**ISSUE:** Permit to Demolish/Capsulate (partial) and Certificate of Appropriateness

**APPLICANT:** Bruce and Thelma MacGregor

105 North Alfred Street

Docket #5 BAR #2021-00329 & 2021-00324 Old and Historic Alexandria District June 1, 2022

Figure 2: Existing north elevation

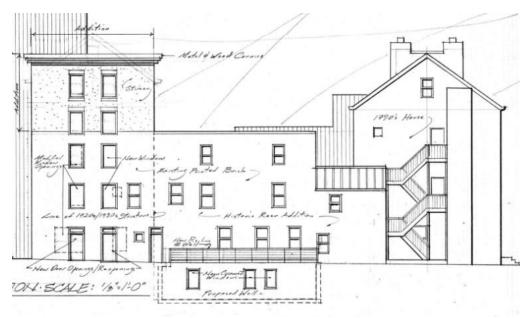
Reconfiguring the windows on the north elevation will provide a degree of symmetry to this elevation, which currently looks very haphazard. See Figure 2. Converting two windows to doors on the east end of this elevation will contribute to the symmetry. See Figure 3. The window well on this elevation will be unobtrusive and allow light into the cellar area. The proposed railing will provide a degree of safety. The applicant must work with staff to ensure that the proposed window well railing confirm with the *Design Guidelines*.

A SOUTH ELEVATION OF ALLEY & COURTYARD . 1/3"=1-0". Existing

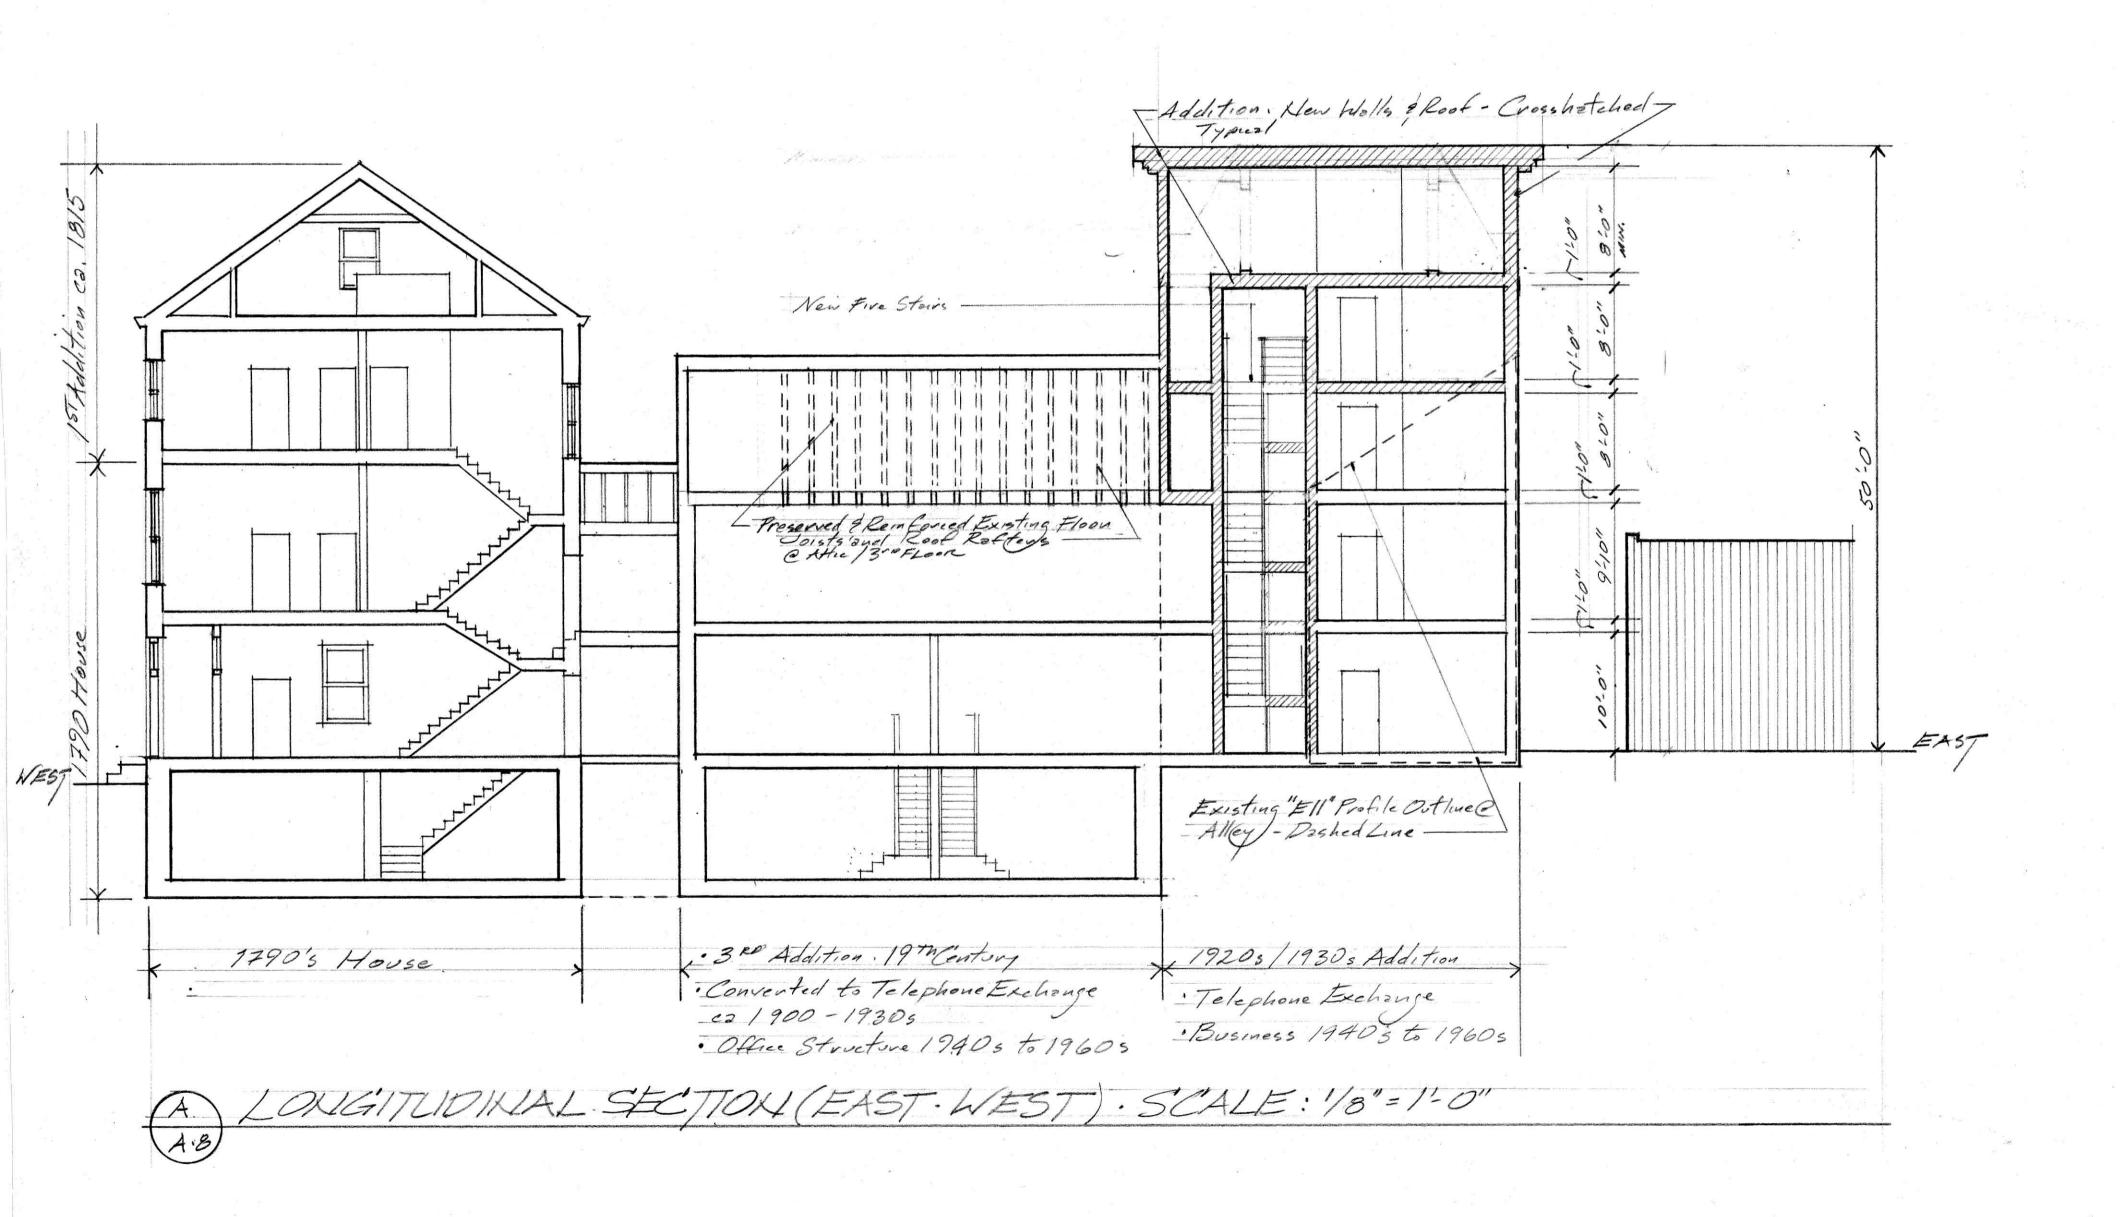
On the south elevation of the ell, the large single-pane window with a Juliet balcony will reopen a pre-existing window here. The applicant must work with staff to ensure that the proposed railings conform with the *Design Guidelines*. The proposed dormers are period appropriate and will be installed retaining as much original construction material as possible. Recent photos indicate that the window configuration on the south elevation of the rear ell was two-over-two double-hung sash prior to their removal. The north elevation of the ell and rear/east addition had multi-pane double-hung sash windows, possibly nine-over-nine. The applicant proposes installing one-over-one windows on the south and north elevations of the ell, and casement windows on the rear/east block and the proposed new addition. Staff recommends that all windows on the ell and on the new construction be one-over-one double-hung sash. On the east elevation, the applicant proposes replacing an existing triple doorway with an elevator.

- 3. The proposed dormers on the south elevation of the ell be slightly narrowed and shifted to retain as much historic fabric as possible, with the final location to be confirmed by staff on site.
